Service Letter No. 481

**SUBJECT:** Muffler and Tailpipe Support

**MODELS AFFECTED:** PA-24 "250" Comanches only, Serial Nos. 24-103 to 24-2174 incl.

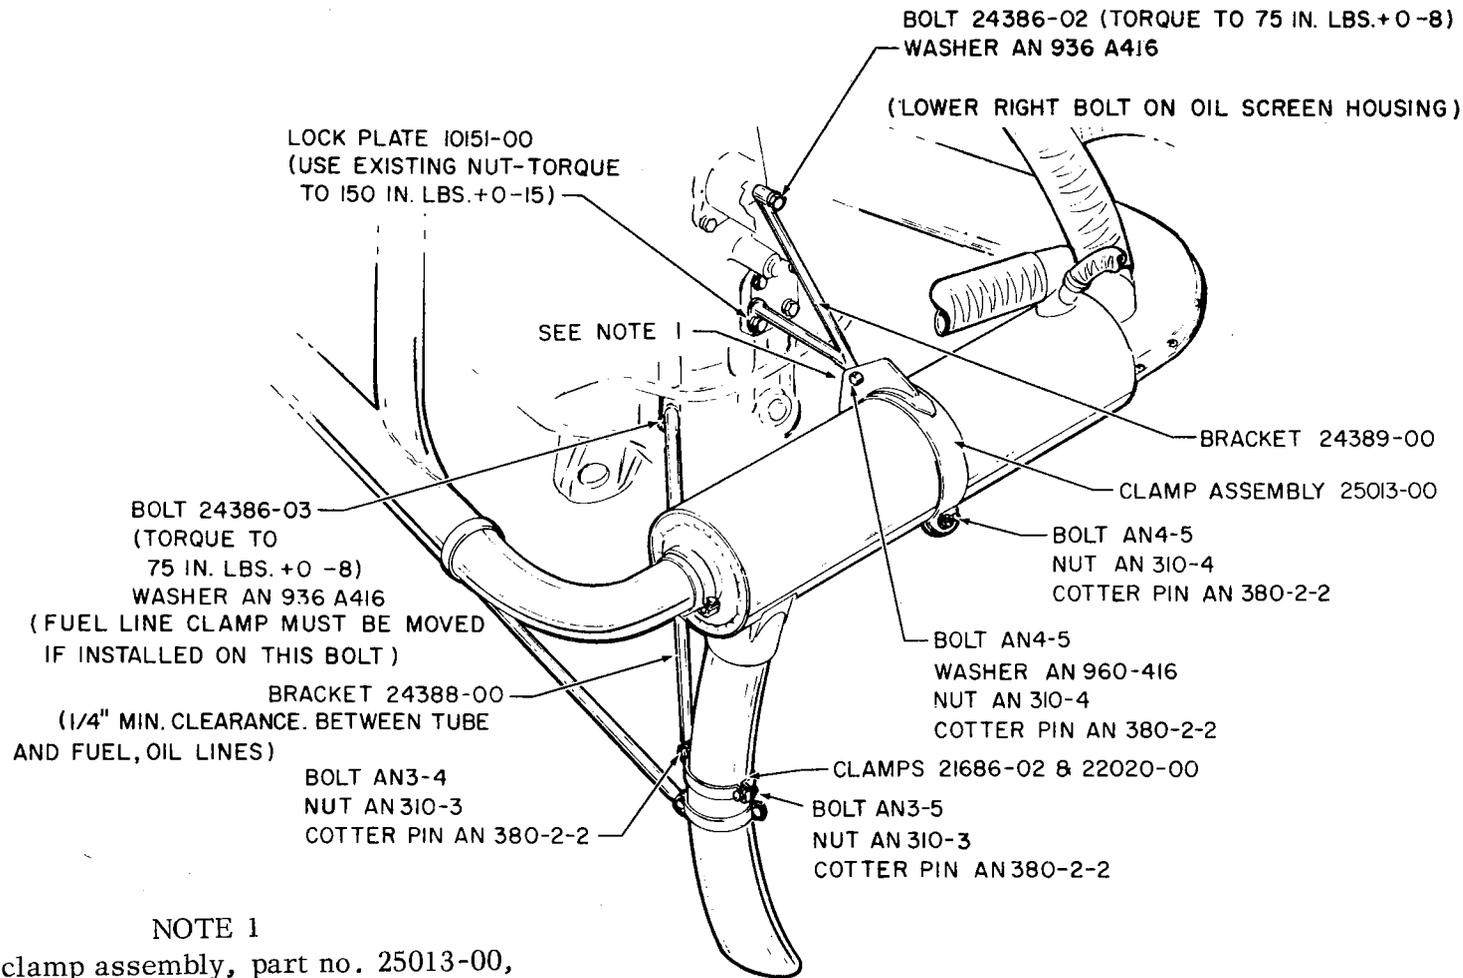
These supports are applicable to the PA-24 "250" Comanches only, within the serial numbers listed above and it is recommended that they be installed on these aircraft as the additional support will be instrumental in extending the service life of the exhaust system. See sketch on the reverse side of this letter.

**NOTE 1**

Drill clamp assembly, part no. 25013-00, as necessary to align with support bracket, part no. 24309-00. (Drill .250 ± 003 Hole)
